1989 - 1990 Corvette: Service Bulletin: Convertible Stowage Lid Not Flush With Rear Deck

Number: 90-183-10 - (02/20/1990)

Subject: STOWAGE LID NOT FLUSH W/REAR DECK-PROCEDURE & STEEL RIVETS

Model Year: 1989-90 Y Car Convertible

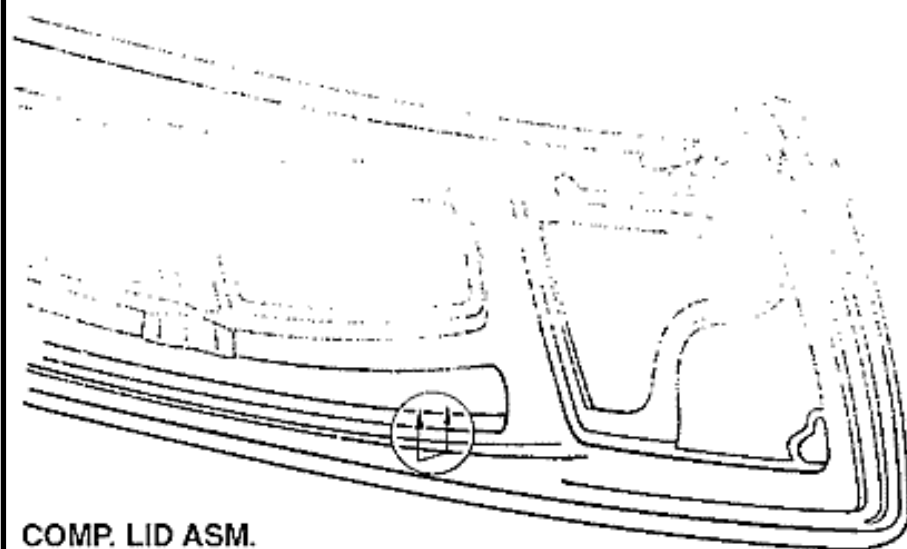
Some 1989 and early 1990 Chevrolet Corvette Convertibles may exhibit a height difference between the stowage compartment lid and the rear deck. This condition may be caused by a lack of adhesive between the steel inner reinforcement and the stowage compartment lid inner panel.

1. Remove the stowage lid as outlined in the Service Manual.
2. Drill 8 (eight) equally spaced 1/8 inch holes through the vertical surface (See Figure 1) of the stowage lid inner panel and the reinforcement.

1. REMOVE STORAGE COMPARTMENT LID FROM VEHICLE AND LAY UPSIDE DOWN ON A CLEAN PROTECTED SURFACE.
2. HOLD WEATHERSTRIP OUT OF THE WAY AND DRILL EIGHT (8) $1/8$ " HOLES IN BACK SIDE THROUGH INNER PANEL AND STEEL REINFORCEMENT (4 HOLES ON EACH SIDE OF CENTER EQUALLY SPACED).
3. INSTALL APPROPRIATE TAPPING SCREW ($5/16$ " LONG) OR STEEL RIVET ($1/8$ " X $1/4$ ").

3. Install 1/8 inch diameter X 1/4 inch long STEEL rivets in the holes.

IMPORTANT: Do not use aluminum rivets as they will not provide the strength necessary to keep the lid from bowing.

4. Coat the rivet heads with touch-up paint to prevent rust.
5. Replace stowage lid as outlined in the Service Manual.
